ZONING BOARD OF APPEALS APPLICATION

Project Street Address: 309 Pondfield Road, Bronxville NY 10768

ZONING REVIEW COMMENTS

APPLICATION NUMB: ALT 226-21
DATE RECEIVED: November 23, 2021
LOCATION: 309 Pondfield Road
SBL: 8./4/5
APPLICANT NAME: Nordic Custom Builders, Inc.
APPLICANT ADDRESS: 525 East Putnam Avenue
Cos Cob, CT 06807

CLIENT	REITER RESIDENCE BRONXVILLE, NY	DATE	01/03/2022
TITLE	CARRIAGE HOUSE PLANS, ELEVATIONS & PARTIAL SECTIONS	SCALE	1/4"=1'-0"
		SHEET	A 110.1

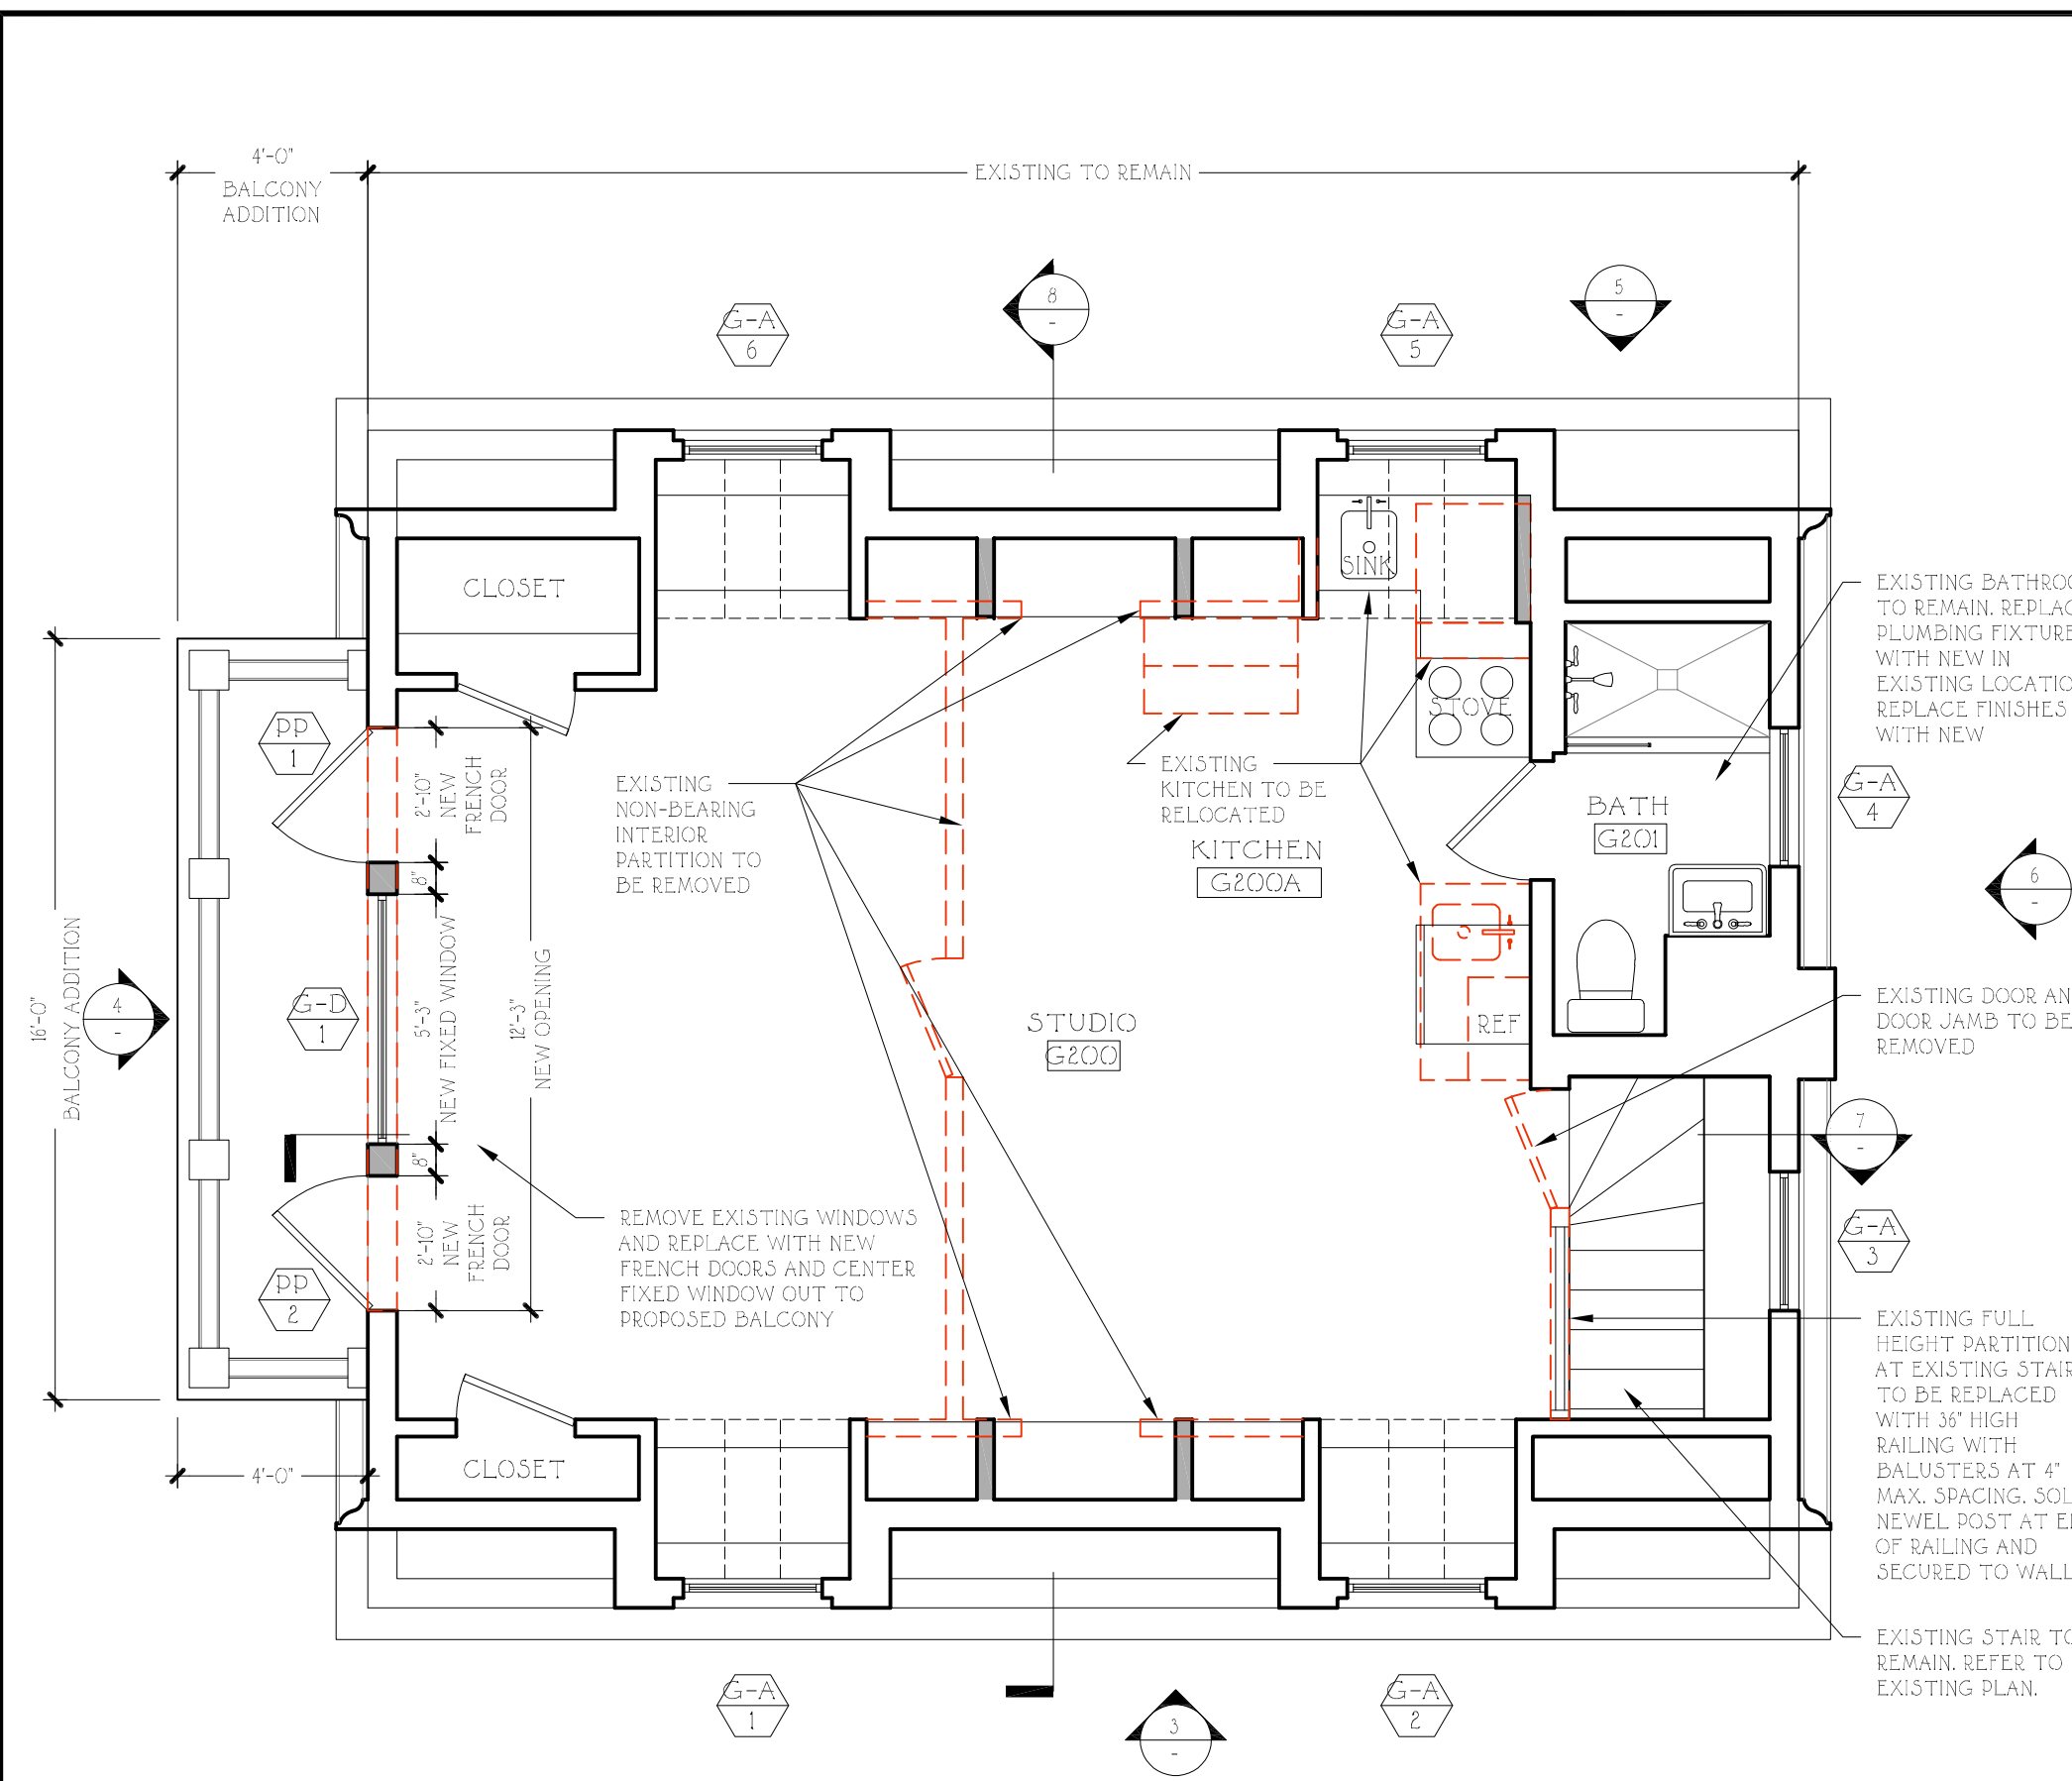
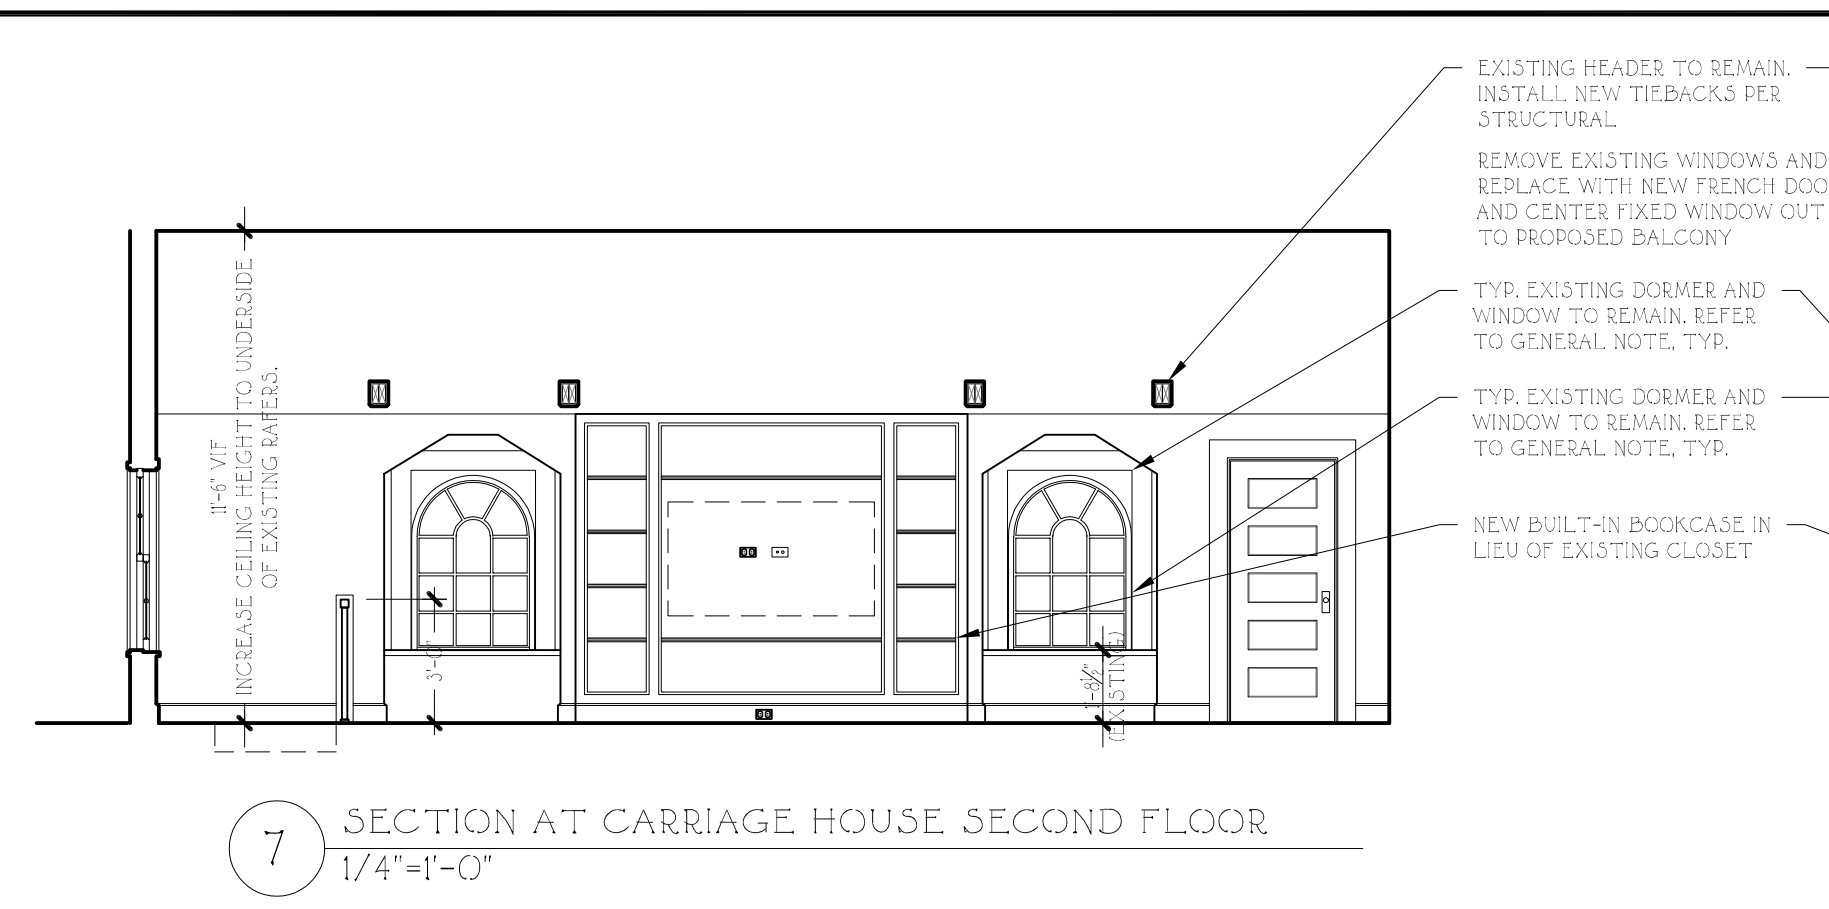
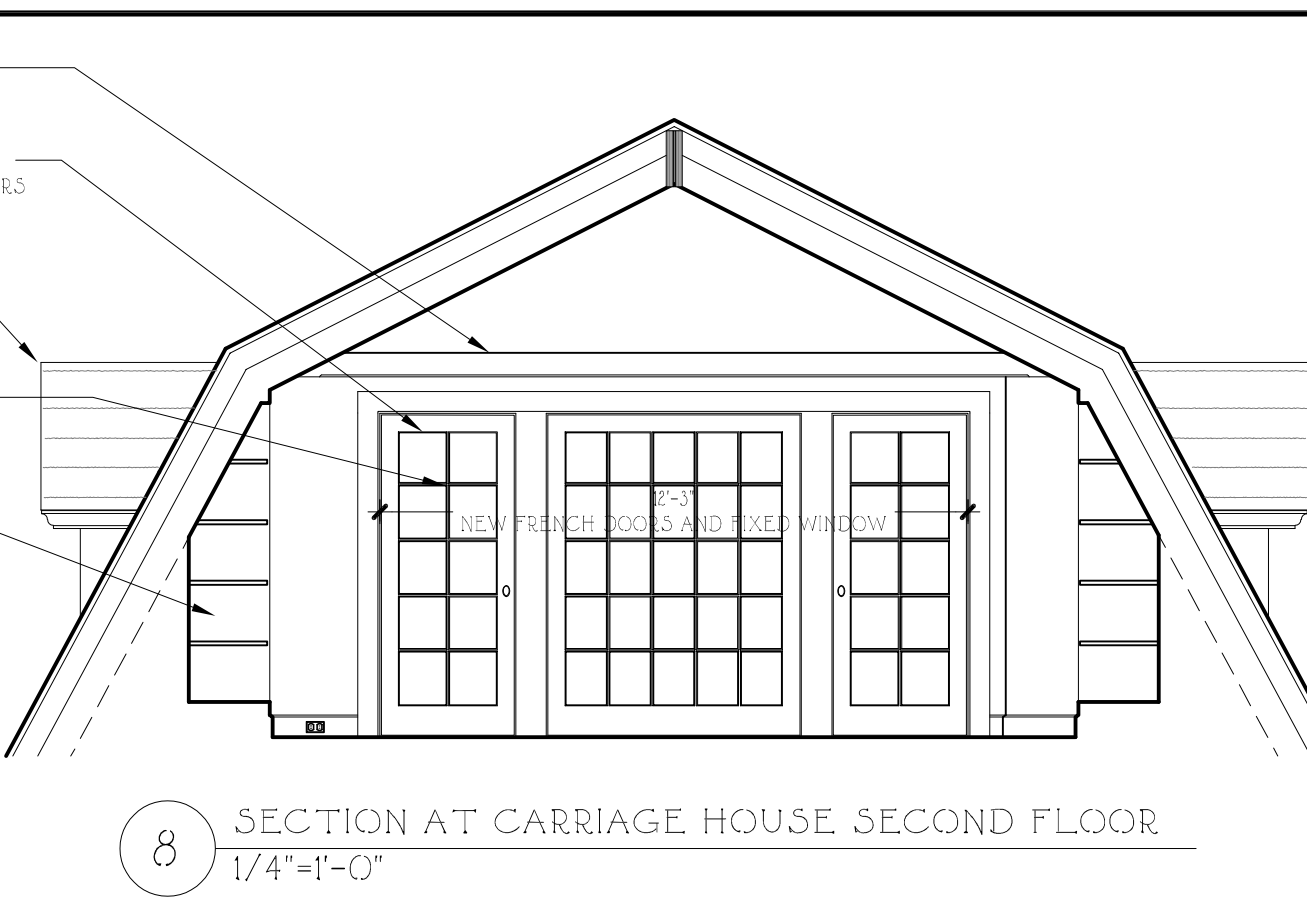
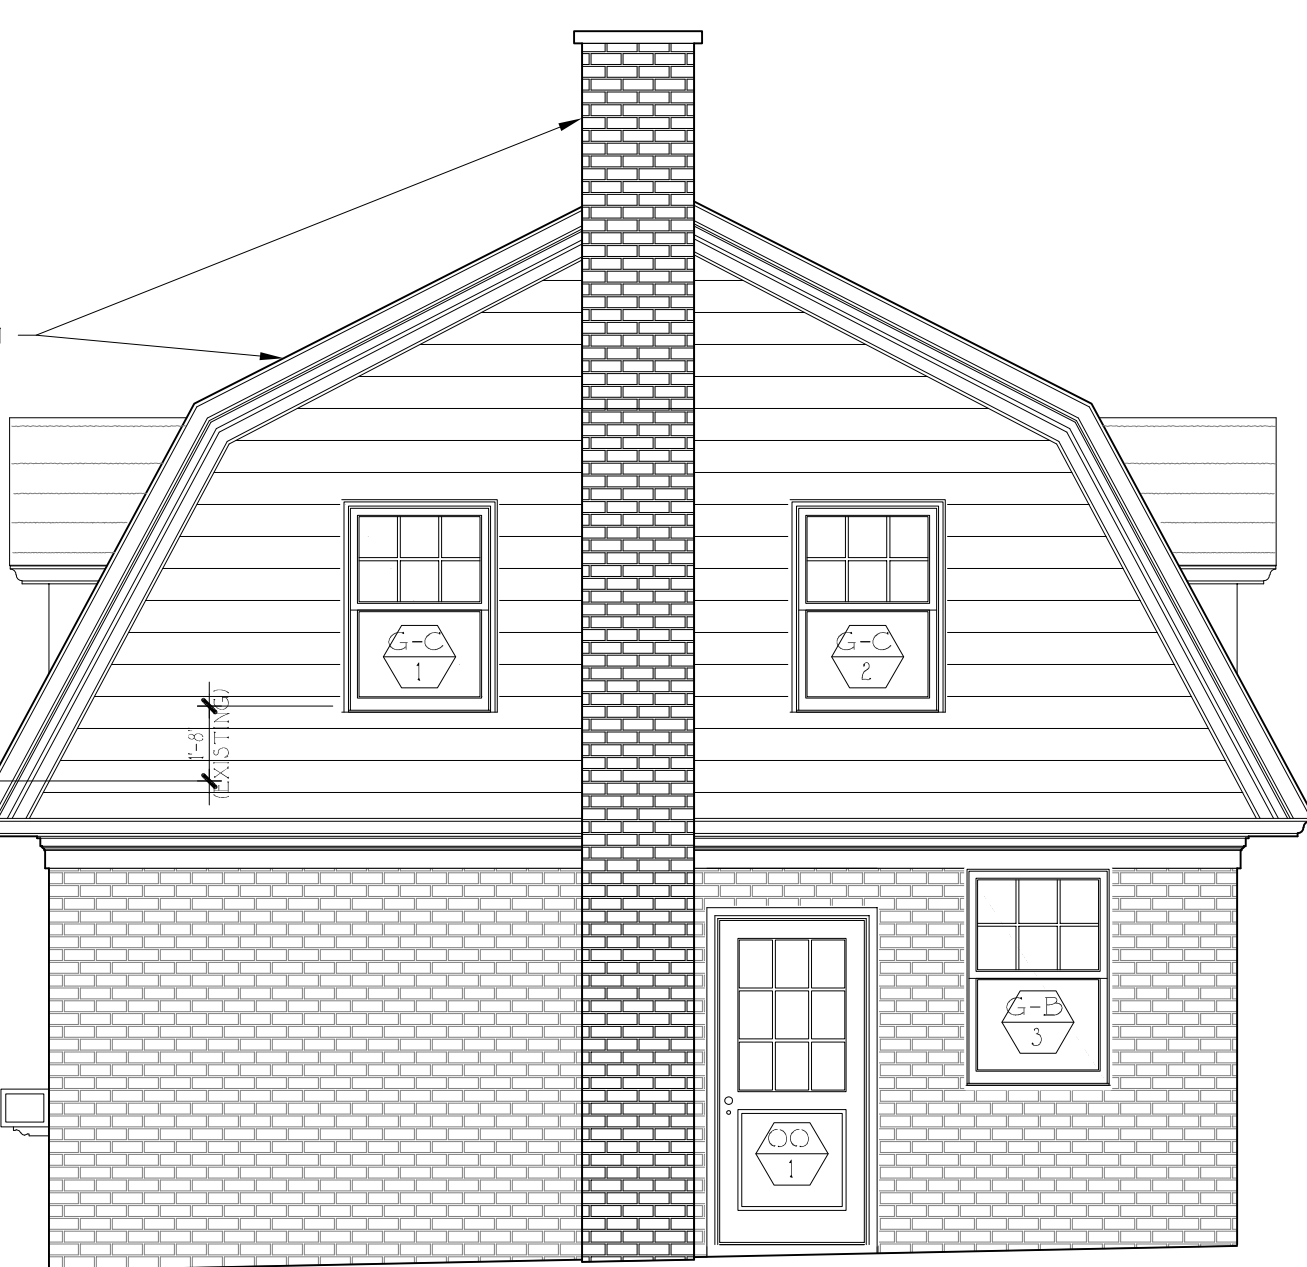
1) Extension of 2nd floor of Garage (Balcony) is an increase in non conformity of the side yard setback (4'-2"). The side yard setback of 4'-2" for the garage is a pre-existing non conformity.

2) Referral to Village of Bronxville Zoning Board of Appeals for an increase on non-conformity inside yard setback - corner lot as per
